HISTORIC AND DESIGN REVIEW COMMISSION

April 05, 2017

HDRC CASE NO: 2017-120
ADDRESS: 615 HAYS ST
LEGAL DESCRIPTION: NCB 530 BLK 14 LOT 4 ARB A-6
ZONING: R-5
CITY COUNCIL DIST.: 2
DISTRICT: Dignowity Hill Historic District
APPLICANT: Steven Martin
OWNER: Todd Worricia
REQUEST:

Site Plan

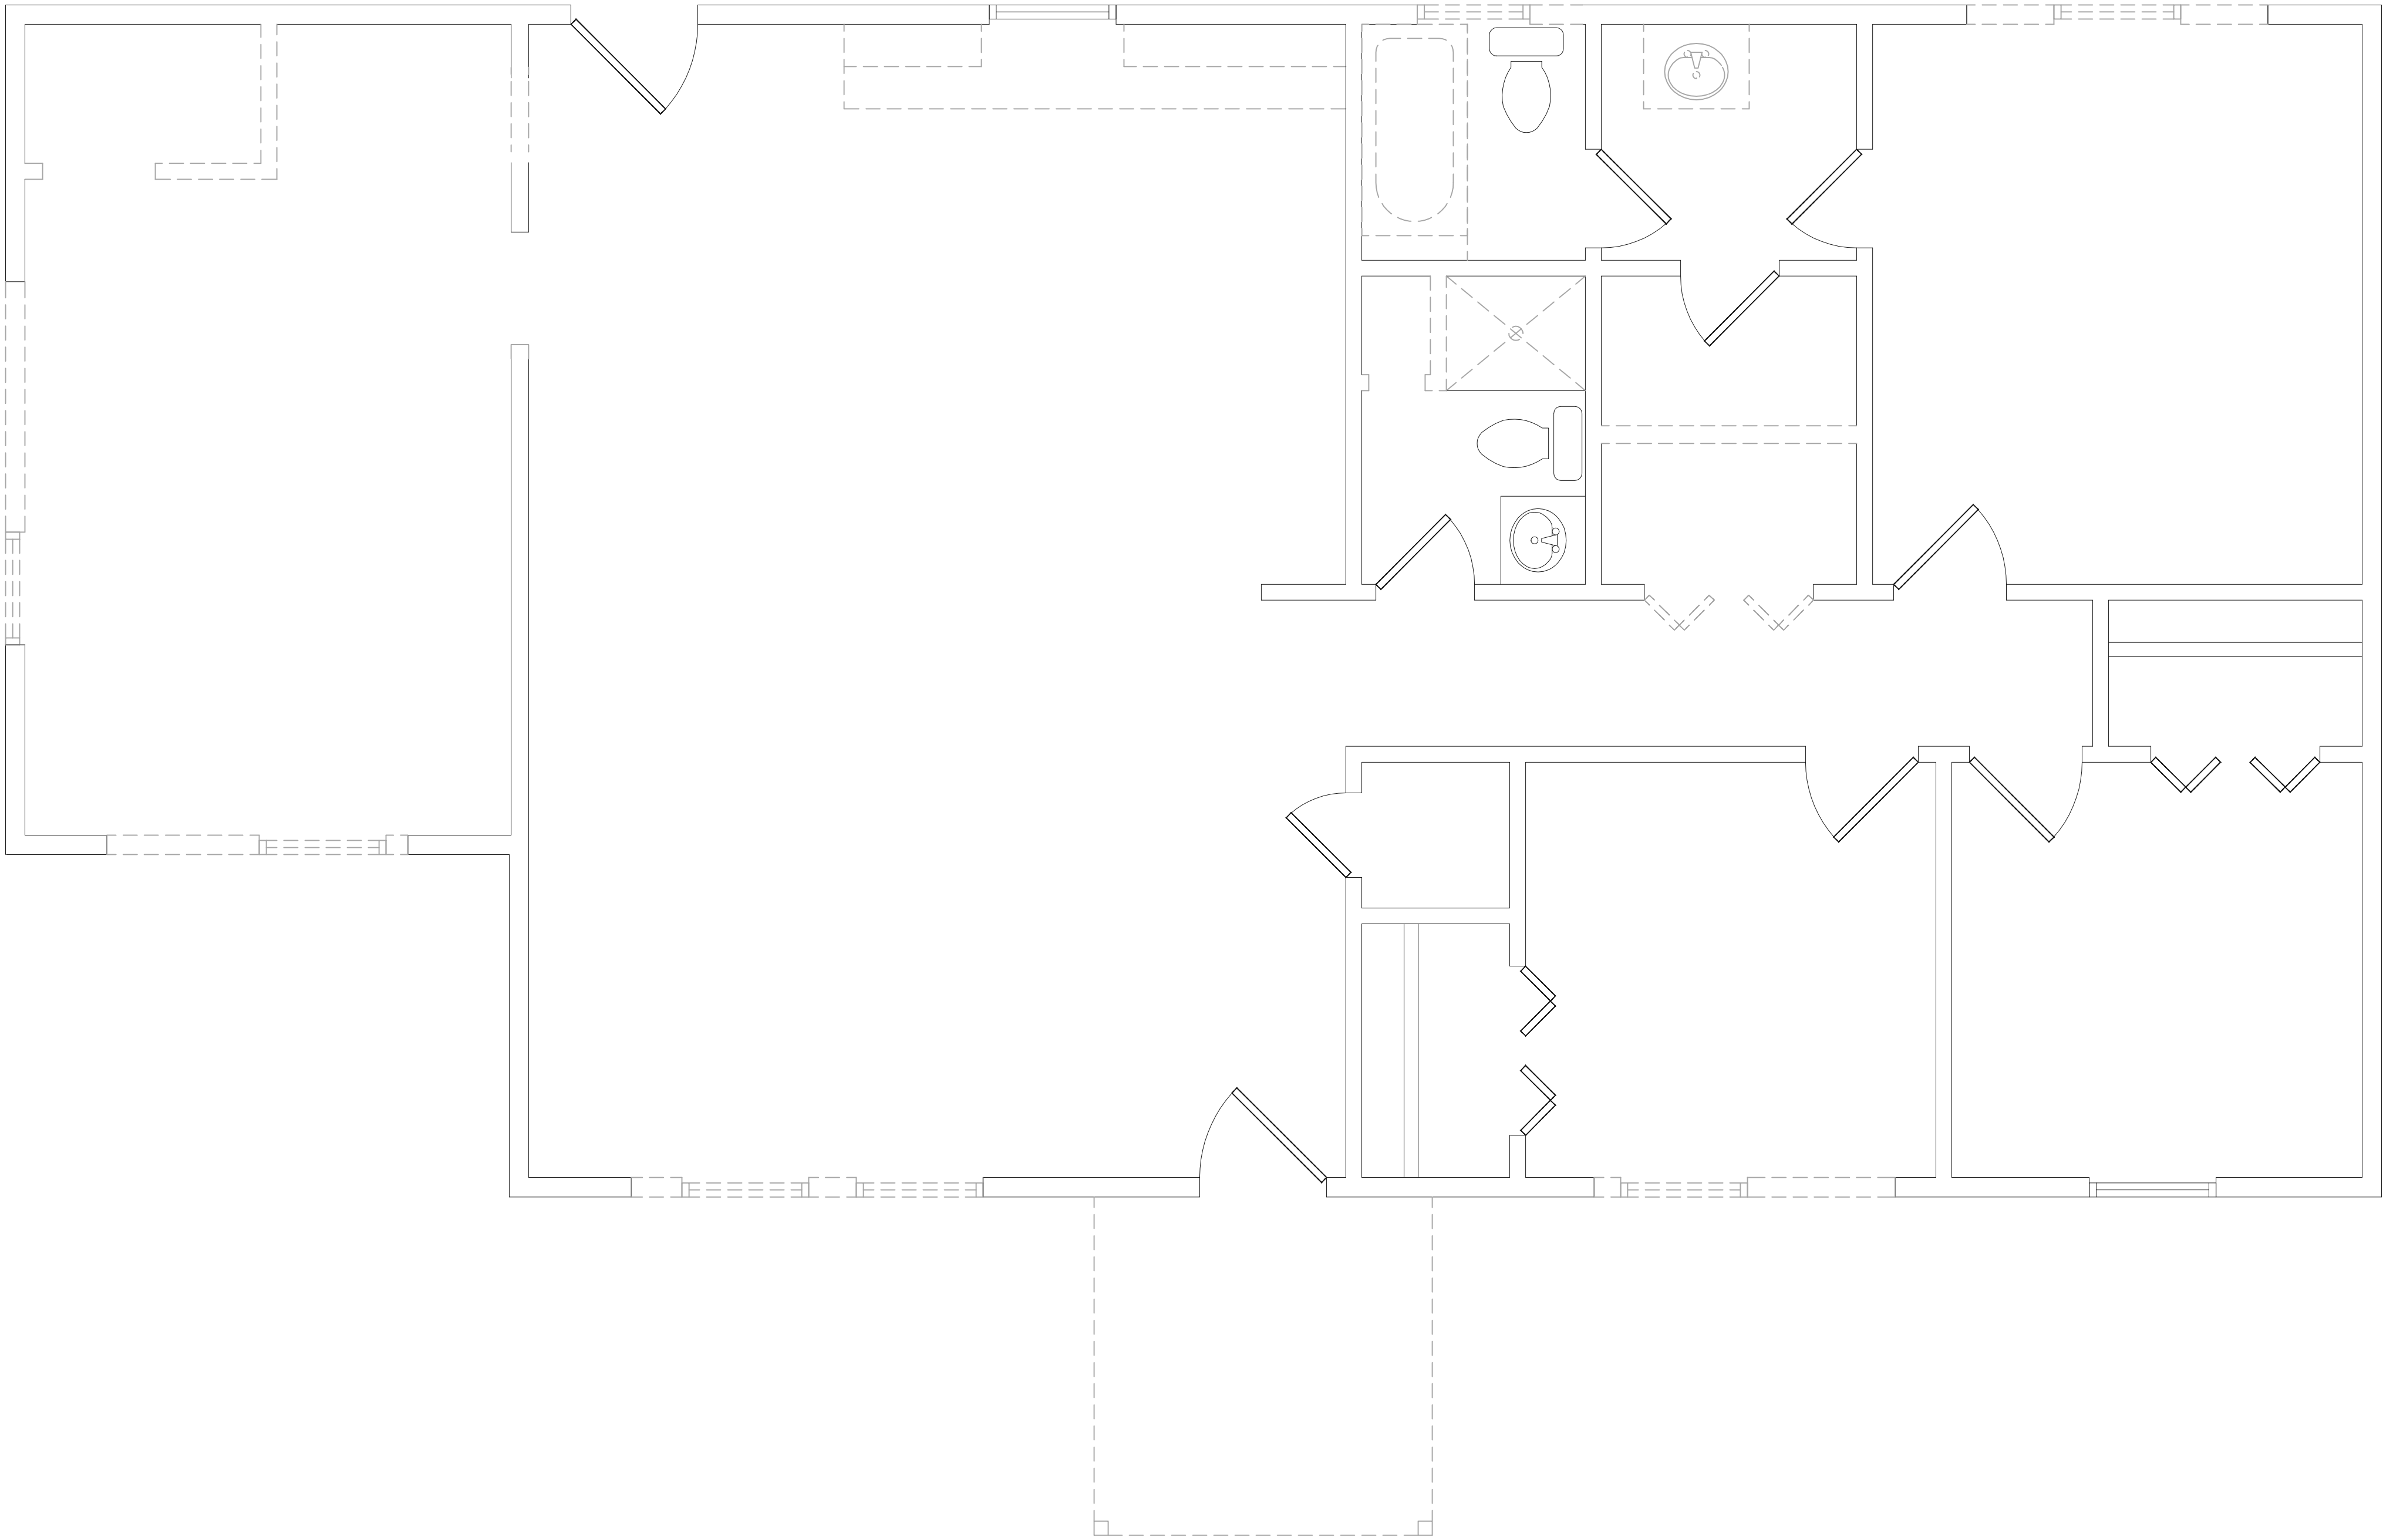
- i. **FENCING** – The lot currently features a front yard chain link fence that features two gates, one at the driveway and another at the front yard sidewalk. The applicant has proposed to remove the chain link fence and install a wooden picket fence, to be painted white. The applicant has noted that the fence will be similar to those located on the 600 block of Hays. The proposed fence will also include a sliding gate for driveway access that will match the remainder of the fence in profile, material and color. Staff finds the removal of the chain link fence appropriate and finds the installation of the proposed wood picket fence appropriate. The applicant shall provide final fencing details that include an elevation drawing of the fence noting a height not exceeding four (4) feet in height prior to receiving a Certificate of Appropriateness.

- j. **DRIVEWAY** – This block of Hays features four houses that address Hays. Each property features a different driveway configurations including varying locations and varying profiles. The applicant has proposed to remove the existing concrete driveway and install a driveway of decomposed granite. Staff finds the proposed driveway modification appropriate; however, the width shall not exceed ten (10) feet in width and must comply with the Guidelines for Site Elements 5.B.i.

- k. **FRONT WALKWAY** – The original front walkway has previously been removed, potentially at the time of the demolition of the original structure. The applicant has proposed to install a new walkway to lead from the front porch to the sidewalk at the public right of way. Currently, the existing front walkway portion at the public right of way does not align with the existing, or proposed front porch. The applicant has proposed a walkway that will feature 3' x 5' concrete pavers. Per the Guidelines for Site Elements 5.A, the historic alignment, configuration and width of sidewalks and walkways on a block should be maintained. Given that the applicant has proposed to install a walkway of concrete pavers, which is reversible, staff finds the proposed installation appropriate; however, the applicant shall provide staff will a detailed landscaping plan noting any landscaping modifications and a detail of how the proposed offset walkway will connect and interact with the existing walkway prior to receiving a Certificate of Appropriateness. Additionally, the proposed pavers shall not feature width inconsistent with the historic walkway widths found on this block; typically three (3) feet.

- iv. That the proposed decomposed granite driveway not exceed ten (10) feet in width and feature a natural brown or tan color as noted in finding j.
- v. That the applicant provide staff will a detailed landscaping plan noting any landscaping modifications and a detail of how the proposed offset walkway will connect and interact with the existing walkway prior to receiving a Certificate of Appropriateness as noted in finding k.

SHEET TITLE:
Front Elevation

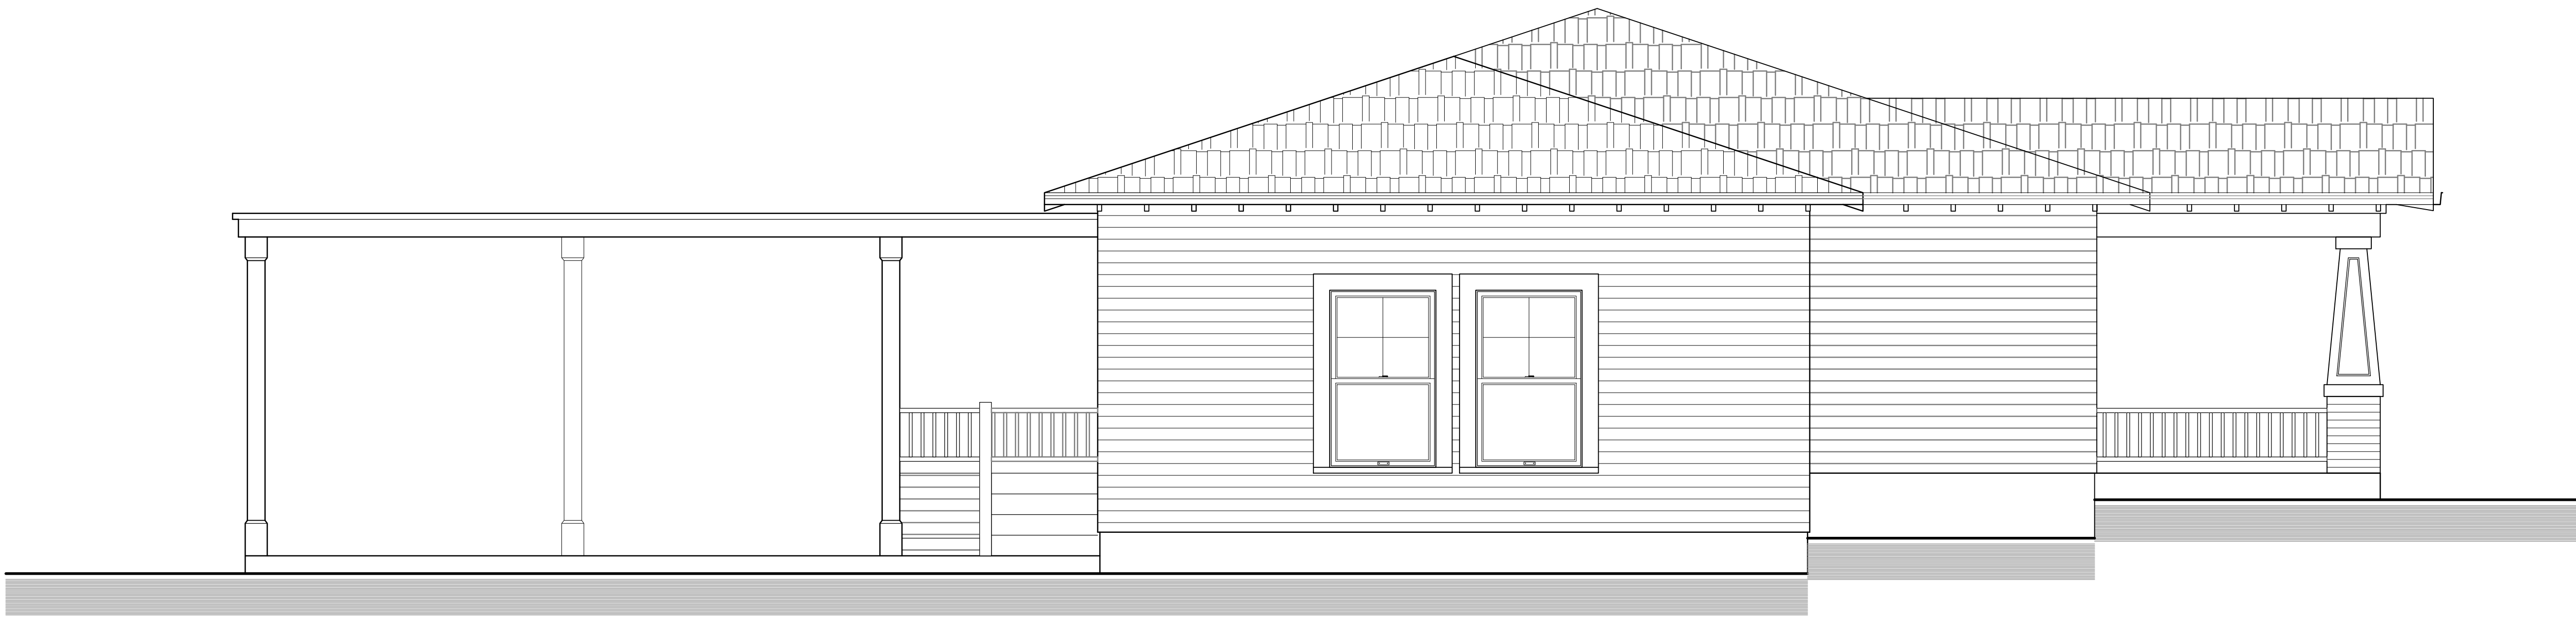
- b. FRONT PORCH MODIFICATIONS – The front façade of the structure currently features a front stoop with a hipped covering that extends approximately eight (8) feet from the front façade. The applicant has proposed to remove these two elements and install a front porch that extends thirty-eight (38) feet across the front façade, features a depth of eight (8) feet and features a front facing gabled roof. To both the right and left of the front facing gabled roof, the applicant has proposed a roof with a shallow pitch of ½. Staff finds the inclusion of the element in accordance with the proposed front gable appropriate. This would not be an appropriate modification to a historic structure.

- c. COLUMN MODIFICATIONS – The applicant has proposed to install Craftsman style columns on the front porch to replace the existing square columns. According to the Guidelines for Exterior Maintenance and Alterations 7.B.v., items that portray a false sense of historic should not be installed. Staff finds the installation of Craftsman style columns on this structure to be inappropriate given its date of construction. Staff recommends the applicant install square columns that are 6” x 6” that feature both a capital and base. With the installation of square columns, the proposed porch railings are architecturally inappropriate and should be removed.

- d. FENESTRATION MODIFICATIONS – The applicant has proposed to relocate the existing windows on the front façade to coincide with the proposed new column placement. Given that these openings are on a structure that holds no historic significance, staff finds this appropriate. An architecturally appropriate installation of double windows would feature a solid trim piece between each window, approximately 6 inches in width. The applicant should incorporate this detail between the proposed double windows. The front façade will feature double windows on both sides of the primary entrance.

- e. FENESTRATION MODIFICATIONS – The far left side of the front façade currently features one single, street facing window. The applicant has proposed to remove this window and install double windows. An architecturally appropriate installation of double windows would feature a solid trim piece between each window, approximately 6 inches in width. The applicant should incorporate this detail between the proposed double windows.

- i. That the applicant install from porch columns that do not portray a false sense of history. Staff recommends the applicant install 6"x6" wood columns with both a capital and base as noted in finding c.

- ii. That all double windows feature a trim piece to separate them that is approximately six (6) inches in width.
- iii. That the applicant provide a fencing detail that includes an elevation drawing of the fence noting a height not exceeding four (4) feet in height prior to receiving a Certificate of Appropriateness as noted in finding k.
